TOWNSHIP OF JOLY LYNCH LAKE PARK
REQUEST FOR QUOTE

RFQ Number Joly RFQ-003

Lynch Lake Park Project RFQ-003

Amendment no. 2024-01

ANCHOR BOLT PLAN
N.T.S.

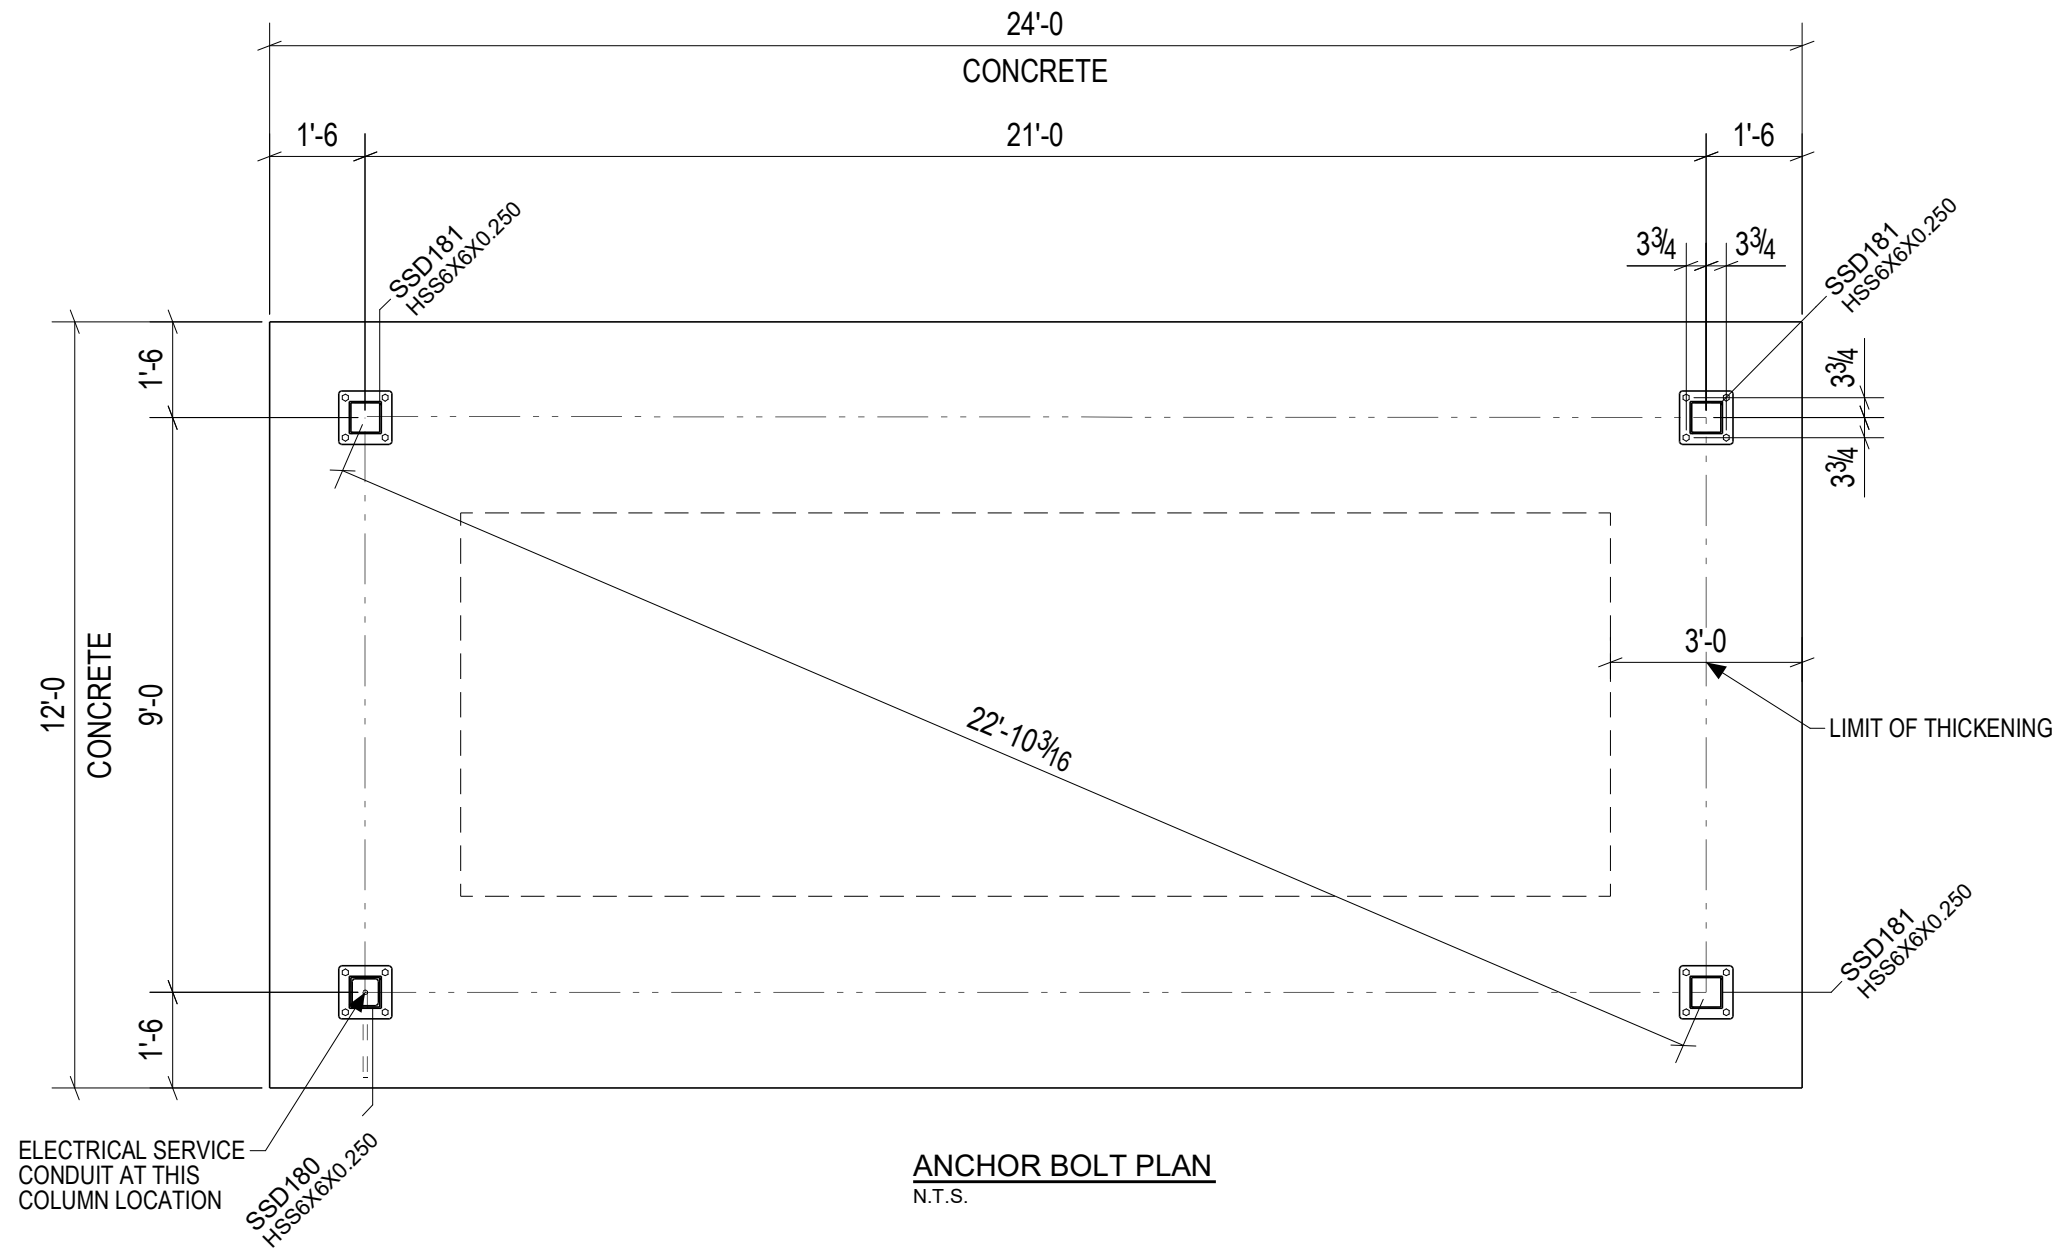
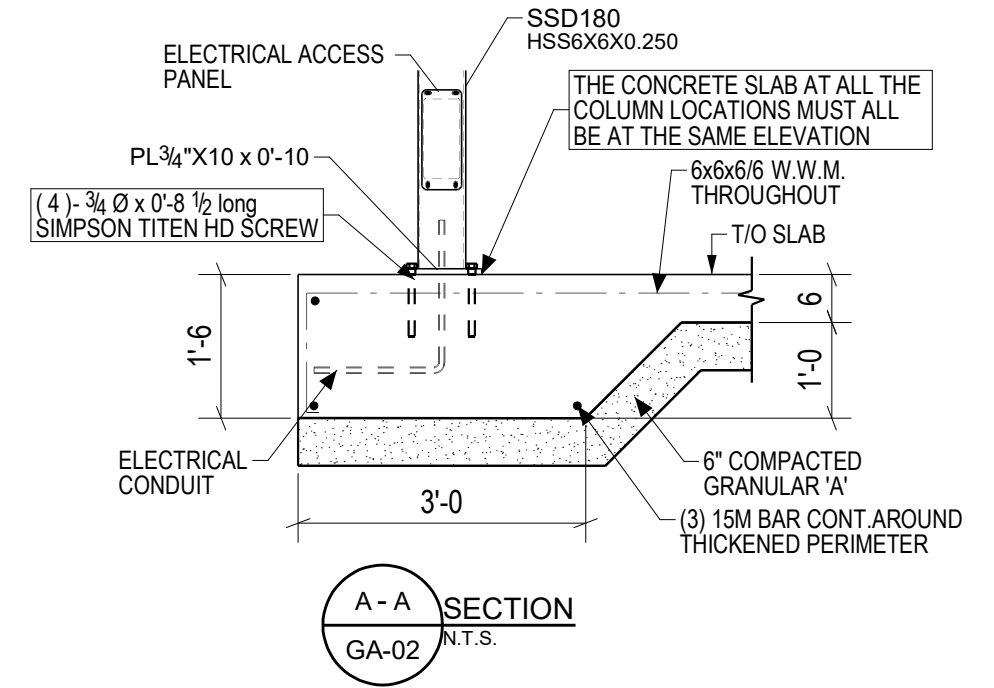
#1. The Township is preparing for the installation of a new 12' X 24' shade structure located at Lynch Lake Park, Joly Township. **The shade structure will sit on slab on grade as per engineered drawings attached.** The existing structure and concrete pad is to be removed, ground is to be leveled with top soil and grass seeded. The complete Request for Quote document is attached for your perusal. Should you have any questions regarding this document or the process,

- The removal of the existing shade structure and removal of the concrete pad it currently sits on and ground area is to be leveled
- **Install slab on grade as per the attached drawings**
- **Concrete to be poured for pad no later than Friday August 30, 2024.**
- **Complete retaining wall for bank stabilization**

Contractor note:
All elevations for top of concrete/ piers at column locations must equal (+/- 1/4")
Any deviation will be subject to shimming and grouting.
Deviation must not exceed 2".
All grouting by others.
